**Bridge Factors Factual Report Attachment 32 – FIGG 3/15/18 Power Point Presentation**

# FIU - Sweetwater University City Bridge

## Temporary Construction Loading Condition

Additional Review of Pylon Diaphragm Region  
(Type II Deck End Diaphragm)

# Local Top Deck Spalls

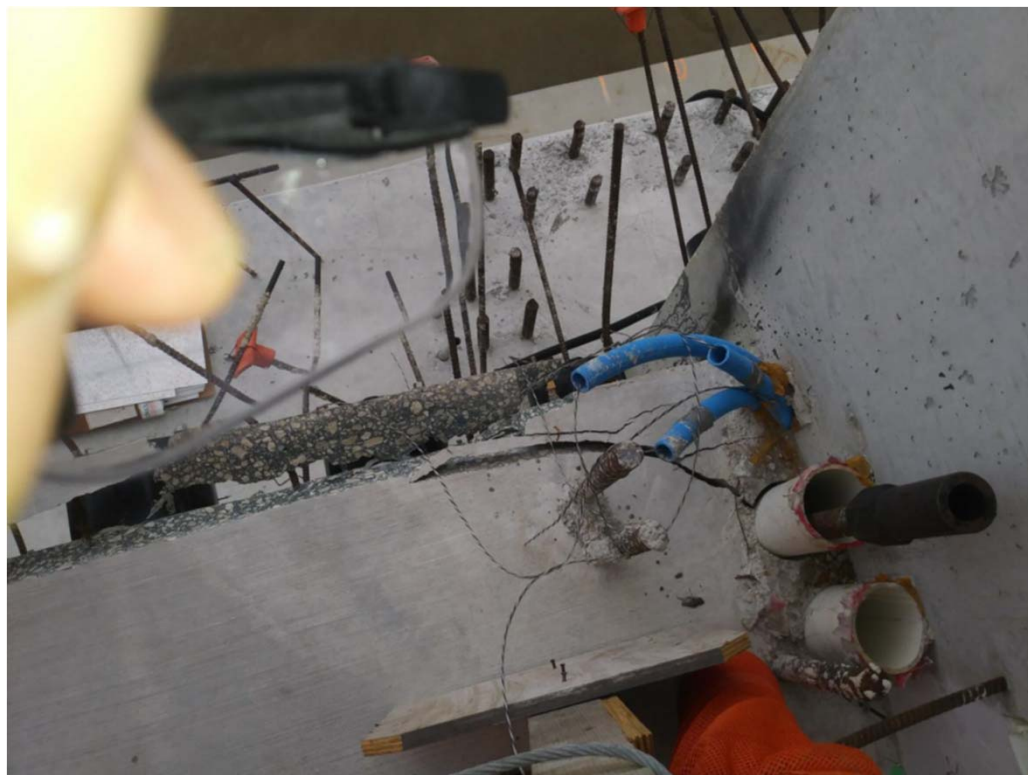
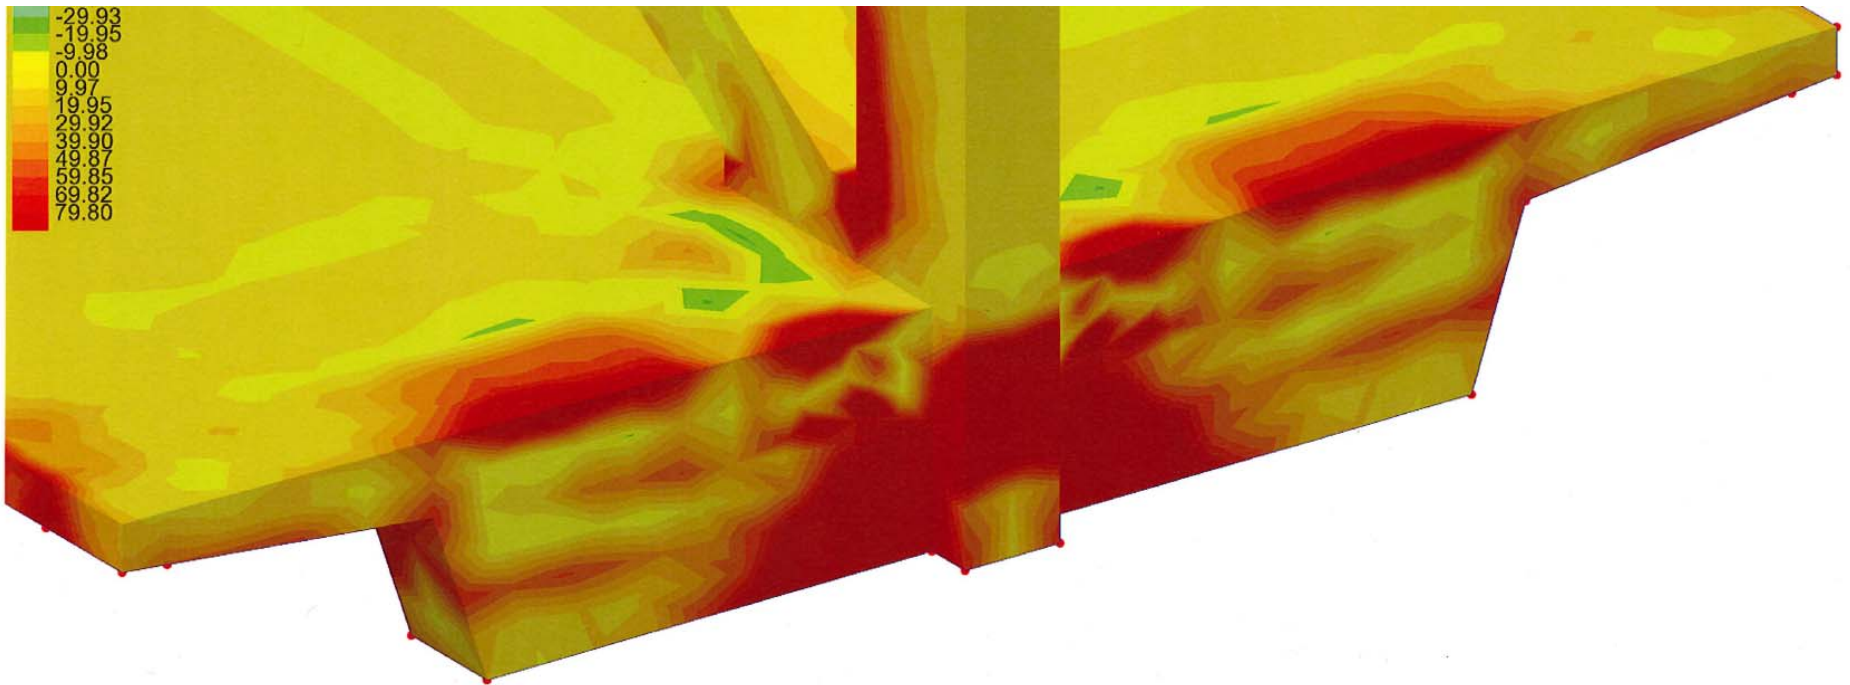
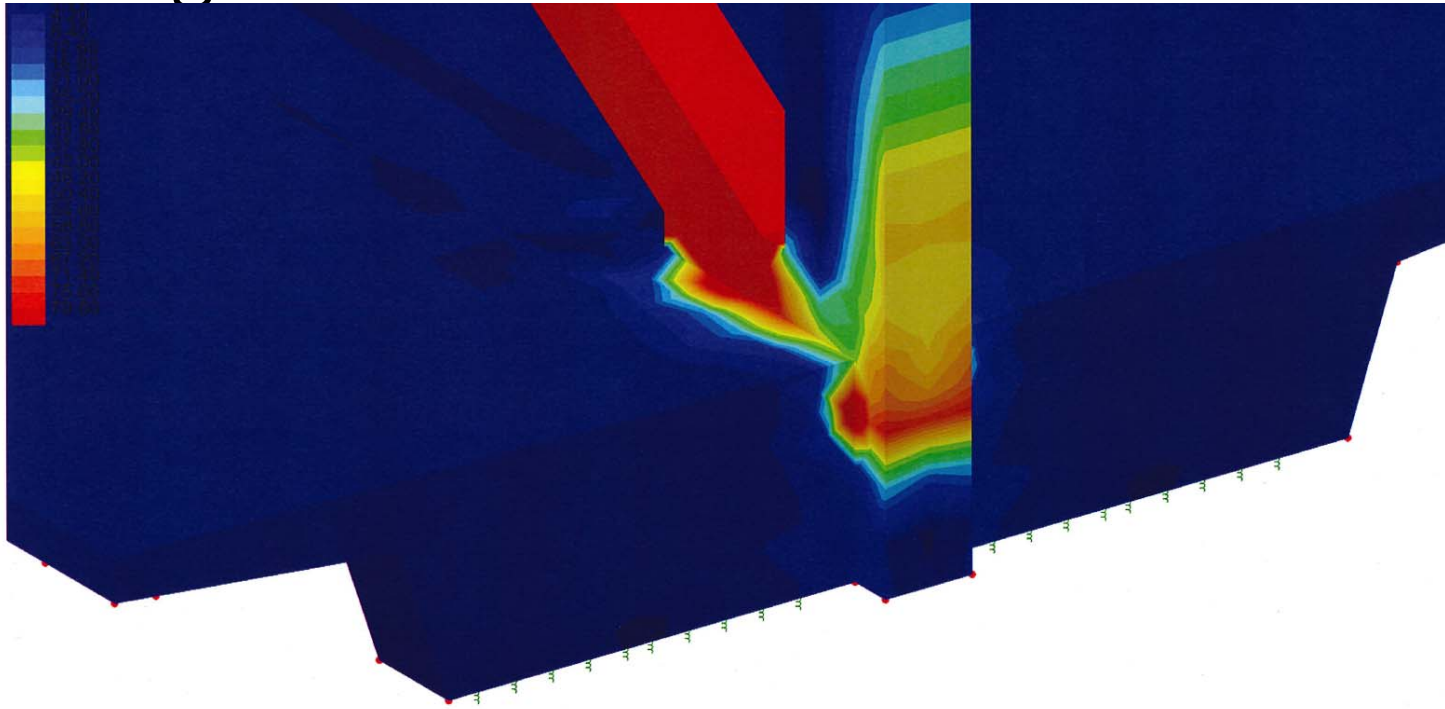
It is unclear how a change in distribution of contact pressure on the bottom surface ...

Could possibly create these top spalls ???

- The analyses (neither total stresses, nor PT bar only stresses) shows any spike in tensile stresses at the corner of the deck/diaphragm/member 12.

- The diagonal type cracks, in excess of FDOT criteria, should be sealed with approved methods and materials (Epoxy injection, etc.)
- The spalled areas have not been replicated by the engineering analyses. However ...
- The spalled areas are minor and it is recommended that they be prepared using normal procedures and poured back along with the up coming “pylon diaphragm” pour (different from and prior to the back span on falsework pours)
